RICKARBY PLACE SUBDIVISION, BLOCK 5,
RESUBDIVISION OF LOT 1

APPLICATION NUMBER 1 DATE November 17, 2022

REQUEST Subdivision

DETAIL SITE PLAN

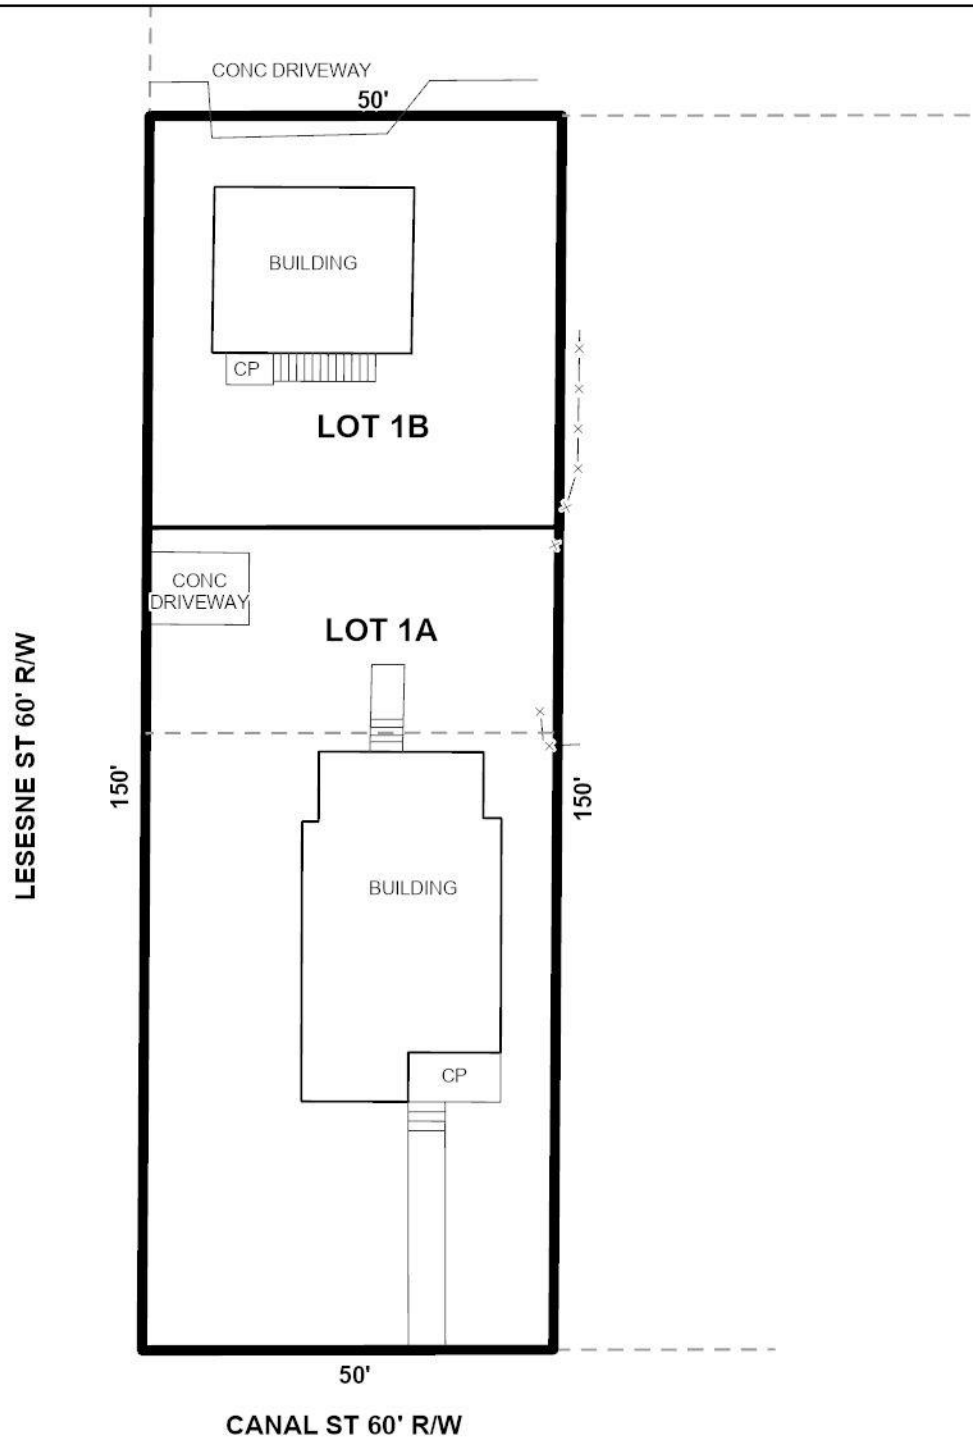
- B. Provide and label the reference monument(s) set at the southwest corner for the SE corner.
- C. Provide a written description for the subdivision boundary.

- D. Dedicate the corner radius (15' minimum or as approved by the City Engineer and Traffic Engineer) at the southeast corner of LOT 1A to the City of Mobile, and list the amount of dedicated acreage in square feet and acres.

- E. Add a note to the SUBDIVISION PLAT stating that as shown on the 1984 aerial photo (FLIGHT 28 - #76) LOTS 1A and 1B will share the historical credit of existing (1984) impervious area towards stormwater detention requirement per Mobile City Code, Chapter 17, Storm Water Management and Flood Control) as follows: LOT 1A – 1,400 sf and LOT 1B – 700 sf.

- F. Revise GENERAL NOTE #16 to read – “All existing and proposed detention facilities, common areas, and wetlands shall be the responsibility of the Property Owner(s), and not the responsibility of the City of Mobile.”

The proposed site has frontage on Canal Street and Lesesne Street, minor streets with curb-and-gutter requiring a minimum 50-foot right-of-way. The preliminary plat illustrates a complaint 60-foot right-of-way for both streets at this location; thus, no additional dedication is required. As on the preliminary plat, the right-of-way widths of Canal Street and Lesesne Street should be retained on the Final Plat, if approved. Dedication of the corner radius at Canal Street and Lesesne Street per Section V.D.6. of the Subdivision Regulations should be required.

The preliminary plat submitted does not illustrate a proposed 25-foot minimum building setback line along the street frontages, which is required by Section V.D.9 of the Subdivision Regulations.

If approved, the Final Plat should illustrate a 25-foot minimum building setback along all street frontages, adjusted for any dedication. It should be noted that both lots appear to have existing structures within the front setback. Any future construction on either lot must comply with setback requirements.

The proposed lots are approximately 5,000± square feet and 2,500± square feet. Both lots do not meet the minimum size requirements of the Subdivision Regulations. As proposed, the approval of the plat would require a waiver of Section V.D.2. of the Subdivision Regulations. It should be noted that the proposed lot sizes are less than those of nearby properties, with the smallest parcel in the area being located at the NW corner of Canal Street and Houston Street, at just over 6,000 ± square feet.

Based on the preceding, this application is recommended for Denial for following reasons:

- 1) Proposed lot sizes are less than the minimum standards of Section V.D.2. of the Subdivision Regulations; and
- 2) The proposed lots would increase the nonconformity of the site with regard to Zoning Ordinance requirements as the lots would not comply with the minimum building area requirements for a R-1, single-family residential district.
